*Preliminary Consultation*  
**MONTGOMERY COUNTY HISTORIC PRESERVATION COMMISSION**  
**STAFF REPORT**

<b>Address:</b>	9 East Irving Street, Chevy Chase	<b>Meeting Date:</b>	5/7/2019
<b>Resource:</b>	Contributing Resource <b>Chevy Chase Village Historic District</b>	<b>Report Date:</b>	4/30/2019
<b>Applicant:</b>	Kristen Levnieks and Joe Poulas (Richard Vitullo, Architect)	<b>Public Notice:</b>	4/23/2019
<b>Review:</b>	Preliminary Consultation	<b>Tax Credit:</b>	Partial
<b>Case Number:</b>	N/A	<b>Staff:</b>	Michael Kyne
<b>PROPOSAL:</b>	Building rehabilitation

*Fig. 1: Subject property.*

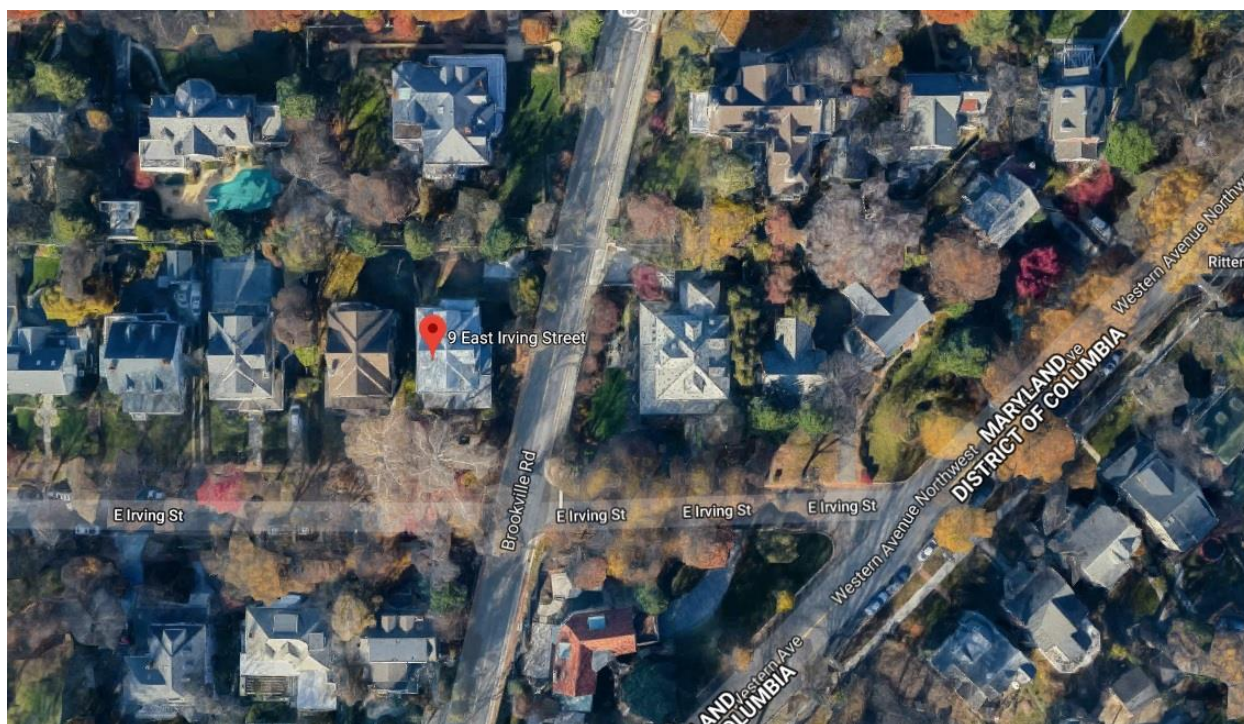
Staff is generally supportive of the proposal, and the proposed in-kind repair/restoration work is all

eligible for the County's Historic Preservation Tax Credit. Where exterior finishes and features are severely deteriorated and beyond repair, staff finds that they should be replaced in-kind. If the applicants propose to replace them with alternative materials, further investigation and documentation will be required.

When submitting a HAWP application, the applicant should include complete details and specifications (i.e., specific information regarding the age and condition of features to be replaced, full existing and proposed railing details, additional information about fenestration infill proposals, roofing material specifications, and full specifications for proposed new windows and doors). Without this information, staff cannot fully evaluate the applicants' proposal for compatibility.

Staff expresses concerns regarding the following aspects of the proposal:

The applicants propose to alter eight fenestration openings on the historic house, including five openings on side elevations - one first-floor door, one first-floor window, and one basement-level window on the west (left) elevation, and two dormer windows on east (right) elevation. These alterations will be at least partially visible from the public right-of-way, and, in accordance with the *Guidelines*, should be reviewed with moderate scrutiny. Regarding moderate scrutiny, the *Guidelines* state the following:

In order to ensure that the integrity of the house is preserved, staff finds that additional information should be submitted regarding the age and condition of the fenestration to be altered. If the fenestration is original, the proposal would remove or alter character-defining features of the historic house, which is inconsistent with the *Standards*.

Staff has the same concerns regarding the removal of the covered porch on the west (left) side of the historic house, the replacement/alteration of the front porch railings, and the replacement of the garage windows and doors.

Regarding the proposed fences, staff is concerned about the proposed 6' high fence at the east side of the property. Typically, the HPC requires all fences forward of the rear plane of the historic house to be no higher than 4' and to have an open design. Staff recommends that the proposed 6' high fence return to the east (right) side of the historic house at the rear corner, making it consistent with the Commission's fence requirements.

Staff recommends that the applicants make revisions based upon the HPC's recommendations and return with a complete HAWP application.
